RAI Volume 3, Chapter 2.2.1.2.1, Sixth Set, Number 4:

Figure 1. Comparison of Stress-Strain Curves Obtained from Tests on 10.5-Inch-Diameter Upper Lithophysal, Saturated Samples with Responses of the Calibrated UDEC Voronoi Block Model

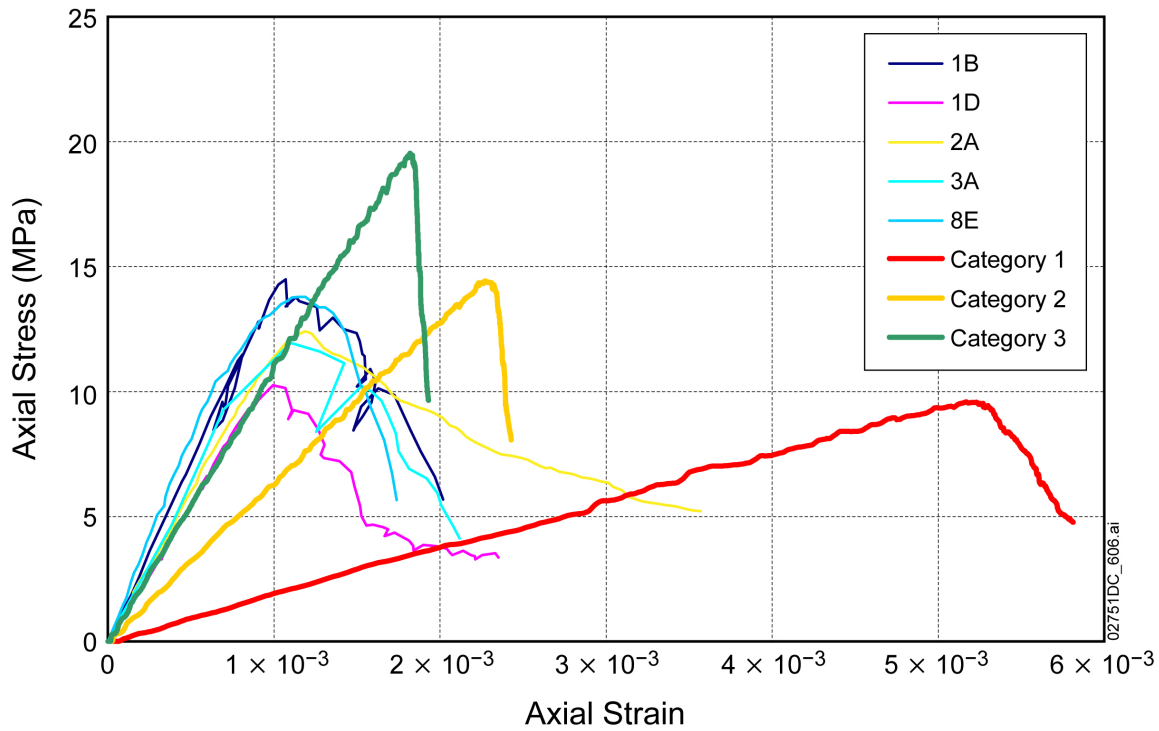
Describe how uncertainties in the stress-strain relationships for the Topopah Spring lower lithophysal tuff have been characterized and considered in the UDEC-Voronoi model. Clarify how post-peak strains are represented in the UDEC model for each rock-mass category, such that the effects of brittle deformation have not been underestimated.

A comparison of the experimental stress-strain curves for all of the saturated 10.5-inch-diameter samples of the upper lithophysal tuff with numerical curves is shown in Figure 1. Note that test data on saturated samples typically had lower strengths than comparable unsaturated samples and the model curves. The saturated samples fell near the lower bound of the strength envelope defining the mechanical property ranges for the five rock mass categories (as shown in SAR Figure 2.3.4-30). Because the UDEC Voronoi data in these plots are for the mean relation between strength and stiffness, the model curves typically show higher strength for the same stiffness. (Development of the relation between strength and stiffness, shown, for example, in Figure E-13, is discussed in BSC 2004, Section E4.1.4.1.) However, comparison of the post-peak softening parts of the stress-strain curves clearly indicates a more brittle model response. That conclusion is more obvious in Figures 2 through 4, in which the curves are roughly divided into ranges of categories and compared with corresponding numerical curves. Brittleness of the UDEC Voronoi block model changes between different categories. As typically observed in rocks, the weaker, less-stiff rocks are more ductile (e.g., Category 1).
